**From:** Light, Cheryl  
**Sent:** Thursday, March 13, 2014 10:47 AM  
**To:** Light, Cheryl  
**Subject:** RE: Requesting Sidetrack Approval: Pettinger 4NE-18HZ API#0512338021

PETTINGER 4NE-18HZ  
 Anadarko  
 7" Intermediate Casing  
 Single Stage

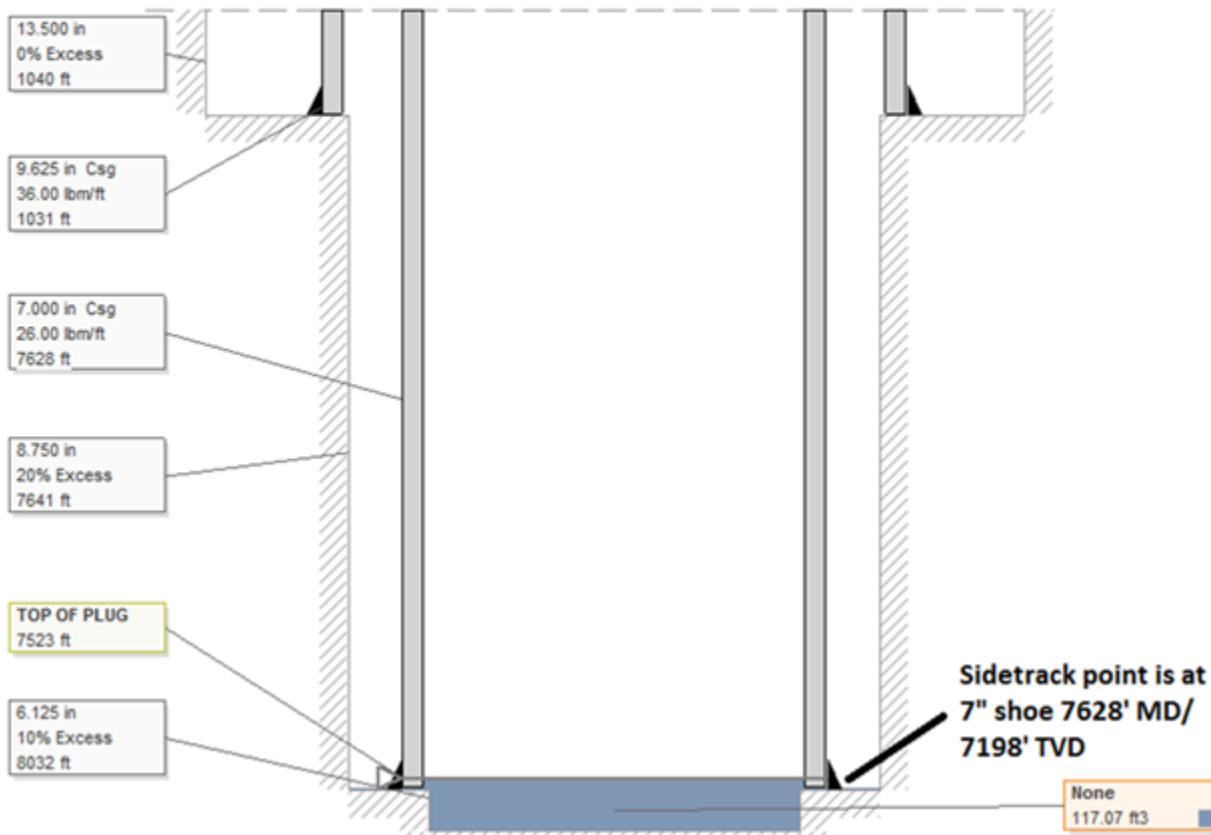
- a. Well name and API - **Pettinger 4NE-18HZ API#0512338021**
- b. Explanation of situation and why you need to sidetrack – **High Inclination and High dog leg in wellbore will cause difficulty in further drilling and while running a liner.**
- c. Total measured depth reached (also have TVD) **8032' MD, 7179' TVD**

- d. Casing sizes set and measured depth **9-5/8" @ 1183' MD/ 1183' TVD, 7" @ 7628' MD/ 7198' TVD**
- e. Description of fish-including top and bottom. **No fish in hole.**
- f. Type of cement you will be using including weight, yield, and sacks. **17.5ppg, .94 ft<sup>3</sup>/sack, 124.5 sacks**
- g. Measured depth and TVD of sidetrack point **7628' MD/ 7198' TVD (at 7" shoe)**
- h. Proposed target formation of sidetrack hole if different than permitted. **Same as permit.**
- i. BHL of sidetrack hole. **Same as original plan.**
- j. Wellbore diagram: **Attached.**

Please proceed as proposed.
